Access Compliance Report

Public Rights-of-Way

Intersection ID: 10036601	Main Street: RUSHMORE_DR	Cross Street: N/A	Location: NE
ADA ID: CF467CC0D110	Ramp Type: PerpDiag	Initial Pass/Fail: Fail	Overall Compliance: No
		Severity Score: 35

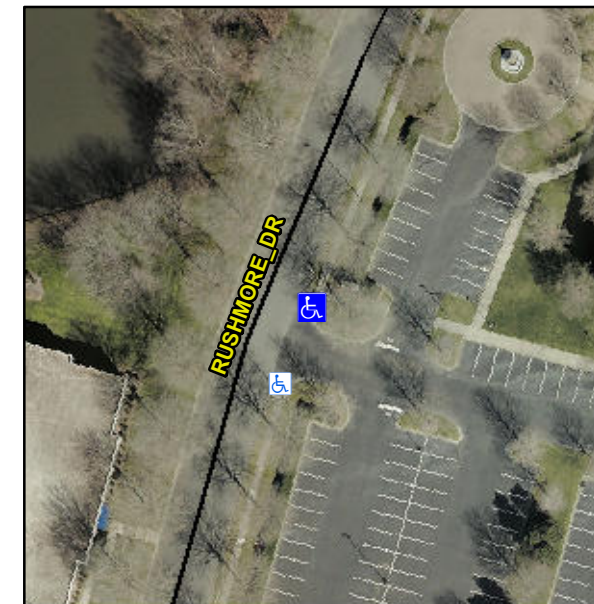
Not Found, R304.5.1, R304.2.2, R304.5.3

Compliance	Description	Data	Compliance	Description	Data
N/A	Ramp Length (in)	49.0	No	Ramp Slope (%)	15.7
No	Ramp Width (in)	46.0	No	Ramp XSlope (%)	3.2
N/A	Flare Type LT	N/A	N/A	Flare Type RT	N/A
N/A	Flare Slope LT (%)	N/A	N/A	Flare Slope RT (%)	N/A
N/A	Flare Traversable LT?	N/A	N/A	Flare Traversable RT?	N/A
N/A	Landing Length (in)	N/A	N/A	DWS Provided?	N/A
N/A	Landing Width (in)	N/A	N/A	DWS Contrast?	N/A
N/A	Landing Slope (%)	N/A	N/A	DWS Length (in)	N/A
N/A	Landing X Slope (%)	N/A	N/A	DWS Full Width?	N/A
N/A	Landing Curb? (Y/N)	N/A	N/A	DWS Offset (in)	N/A
N/A	Shared Landing?	N/A			
N/A	Gutter Ponding?	N/A	N/A	Gutter Slope (%)	N/A
N/A	Gutter Lip Ht (in)	N/A	N/A	Gutter X Slope (%)	N/A
N/A	Painted X Walk1?	No	N/A	Painted X Walk2?	No
	X Walk 1 Direction	To NW		X Walk 2 Direction	To SW
N/A	X Walk 1 Width (in)	N/A	N/A	X Walk 2 Width (in)	N/A
	X Walk 1 Slope (%)	3.9		X Walk 2 Slope (%)	1.3
	X Walk 1 X Slope (%)	0.6		X Walk 2 X Slope (%)	5.5

Remove & Replace Curb Ramp With Two New Directional Ramps or Equivalent.
